DEVELOPMENT APPLICATION ASSESSMENT REPORT

Application Number:	DA2021/0433
----------------------------	-------------

Responsible Officer:	Gareth David
Land to be developed (Address):	Lot 24 DP 221359, 76 Nandi Avenue FRENCHS FOREST NSW 2086
Proposed Development:	Alterations and additions to a dwelling house including a swimming pool
Zoning:	Warringah LEP2011 - Land zoned R2 Low Density Residential
Development Permissible:	Yes
Existing Use Rights:	No
Consent Authority:	Northern Beaches Council
Land and Environment Court Action:	Yes
Owner:	Patrick Allan Soper Fiona Elizabeth Lousia Soper
Applicant:	Patrick Allan Soper

Figure 1: Side boundary envelope breach on the northern elevation shown in green

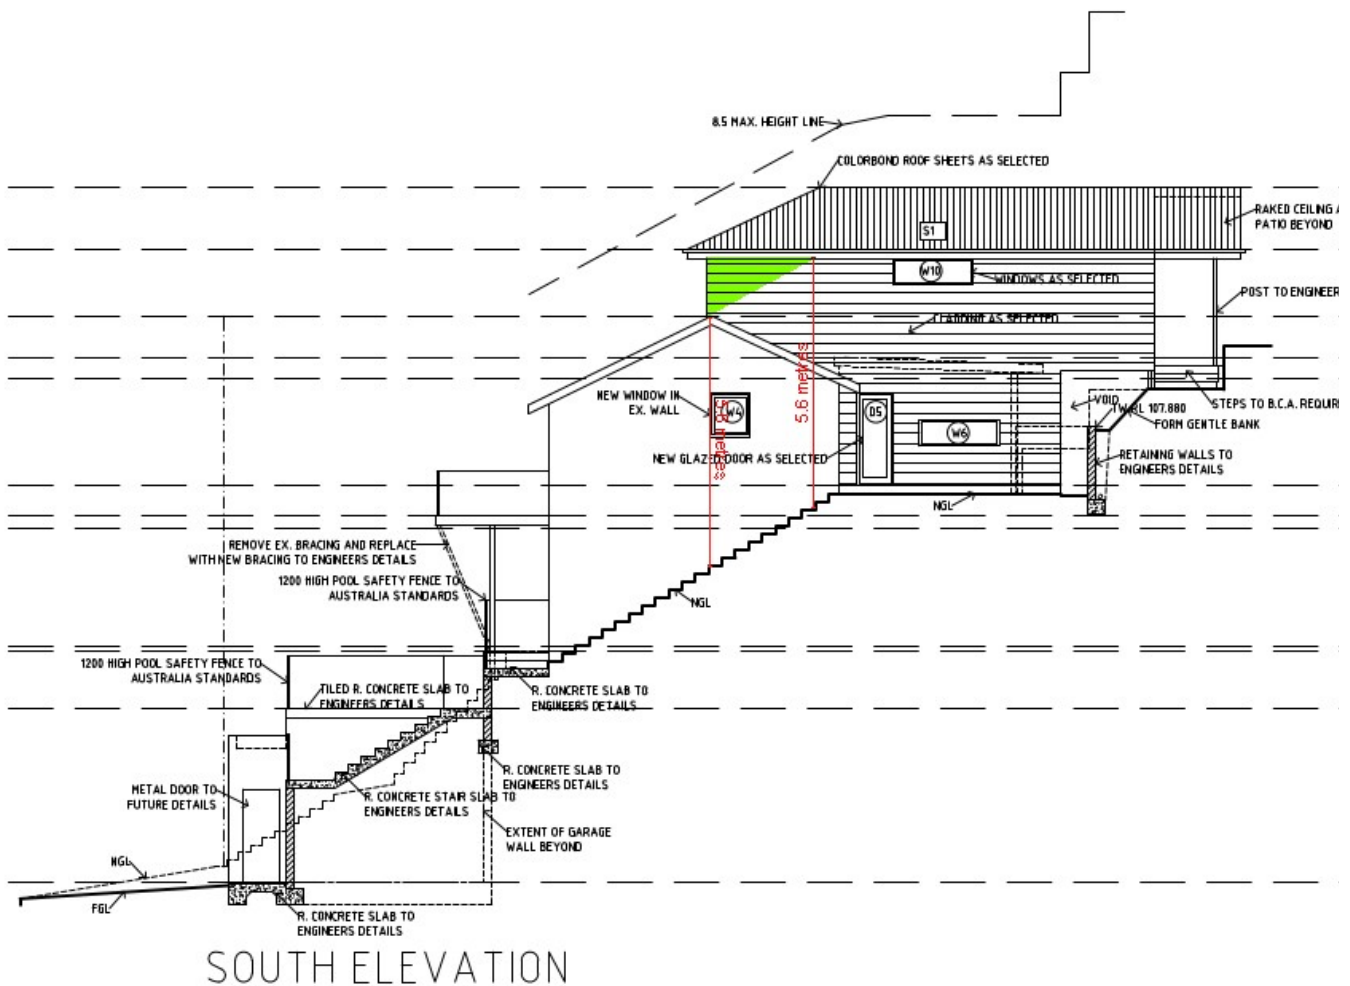
Clause B3 of the WDCP 2011 stipulates that buildings are to be projected at 45 degrees from 4m above the existing ground level, measured from the side boundaries. The proposed first floor addition to the rear of the existing dwelling largely complies with the prescribed building envelope control, with the exception of the south-west corner of the addition.

The figure below show the location and extent of the non-compliance.

Notwithstanding the building envelope breach, the development will not present an unreasonable degree of bulk and scale with sufficient separation provided to the adjoining property at No 78. The first floor addition will be setback 1.6m from the southern boundary, in excess of the minimum setback required by WDCP. While the addition will be sufficiently

setback from Nandi Avenue and will to not have an unreasonable impact on the streetscape character. The dwelling will remain two storey, consistent with the established built environment of the surrounding area.

The application is supported by shadow diagrams which demonstrate sufficient solar access to the southern adjoining property at No 78. Only one highlight window is proposed on the southern elevation of the addition providing adequate visual privacy to the adjacent property.

Having regard to the above assessment, it is found that the proposal is consistent with the outcomes of the control. It is concluded that the proposed development is consistent with the relevant objectives of WDCP and the objectives specified in s1.3 of the Environmental Planning and Assessment Act, 1979. Accordingly, this assessment finds that the proposal is supported, in this particular circumstance.
